WATER	DIVISION	IN	ISP	EC	TIOI	N REPORT
			ERMIT #: AR0036692 DATE: 5/2/2018						
— A	R K A N S A S	CO	UNTY: 57 Polk		F	PDS #	ŧ: 103	053	MEDIA: WN
Dep	partment of Environmental Quality	-	SLAT: LO			TION			
NAME	FACILITY INFORMAT	ION						INFOR	MATION
City of Mena WWTP			FACILITY TYPE: INSPECTOR ID#: 1 - Municipal 34946 S - State						
	3 Polk 53			FACILITY EVALUATION R. 2 - Marginal	ATING:				ION TYPE: /Collection System
CITY: Me	na, AR			DATE(S): 5/2/2018	ENTR	Y TIME:		TIME: :45	PERMIT EFFECTIVE DATE:
RESPONSIBLE OFFICIAL			0/2/2010	00.		17		9/1/2017 PERMIT EXPIRATION DATE:	
Но	NAME: / TITLE Honorable George McKee / Mayor								8/31/2022
COMP	y of Mena			FAYETTEVILLE SHALE RELATED: N					
MAILI	NG ADDRESS:			FAYETTEVILLE SHALE VIOLATIONS: N					
	3 Polk 53 state, zip:			NAME/TITLE/PHONE/FAX/			ION I	PARTIC	CIPANTS
Ме	na AR 71953						enan	ce, Wa	ater Department / 479-
479	9-394-4585 /								
EMAIL	keemayor@sbcglobal.net

In response to AR0036692 inspV 20180502 Collection System Inspection, three deficiencies were noted:

RE: City of Mena WWTP - Response to Inspections (Polk Co) AFIN: 57-00423 NPDES Permit No.: AR0036692

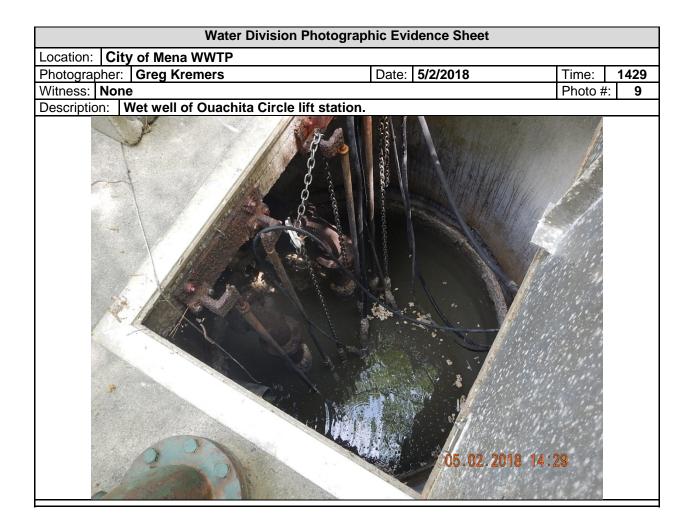
1. For the Mid-South lift station	า:							
 An active overflow from the manhole associated with this lift station was observed entering a 									
	nearby creek at the t	ime o	of the inspectio	n.					
	 Audible and visual al 	larm	s were not func	tioning to indi	cate	high	-wate	r level	s during the overflow
	event.								
	 For the Ouachita Circle lift station: The visual alarm did not operate during the test function. 								
	The visual alarm did	not	• •		m.				
An	inspection of the collection system	em fo			icted	d on l	May 2	2. 2018	in conjunction with a
An inspection of the collection system for the City of Mena was conducted on May 2, 2018 in conjunction with a CEI of the treatment plant. There are four lift stations with three of those being assessed during the									
inspection: Mena Schools, Mid-South, and Ouachita Circle.									
Upon arrival to the Mid-South lift station, wastewater was observed overflowing at a manhole and entering a

ADEQUATE VENTILATION TO PREVENT EXCESSIVE CON GASES AND FUMES:	NDENSATION AND/OR	ØS OM OU ONA ONE	
ADEQUATE LIGHTING FOR ROUTINE INSPECTION/MAIN	TENANCE:	ØS OM OU ONA ONE	
SEALS, VALVES AND PACKING ADEQUATELY MAINTAIN	ED TO PREVENT LEAKS:	□S □M □U □NA ØNE	
MINIMAL ACCUMULATION OF GREASE AND SOLIDS IN V	VET WELLS:	ØS OM OU ONA ONE	
BACKUP POWER AND ALARMS		⊡S ⊡M ⊠U ⊡NA	
PROVISIONS FOR GENERATOR AND/OR EMERGENCY T and onsite generator.		ØS OM OU ONA ONE	
AUDIBLE/VISUAL ALARM WITH EMERGENCY CONTACT I Audible and visual alarm not functioning during overflow		□S □M ØU □NA □NE	
SCADA SYSTEM (LIST PARAMETERS MONITORED):	<u>.</u>	□Y □N ØNA □NE

1. For the Mid-South lift station: An active overflow from the manhole associated with this lift station was observed entering a nearby creek at the time of the inspection. Mena Water Utilities cleaned up the overflow and submitted an overflow report to ADEQ. Additionally, the controls were inspected and repaired by an electrician.

- 2. For the Mid-South lift station: Audible and visual alarms were not functioning to indicate high-water levels during the overflow event. Mena Water Utilities has had an electrician inspect and repair the audible and visual alarms.
- 3. For the Ouachita Circle lift station: The visual alarm did not operate during the test *function.* Mena Water Utilities has repaired the visual alarm by replacing the bulb.
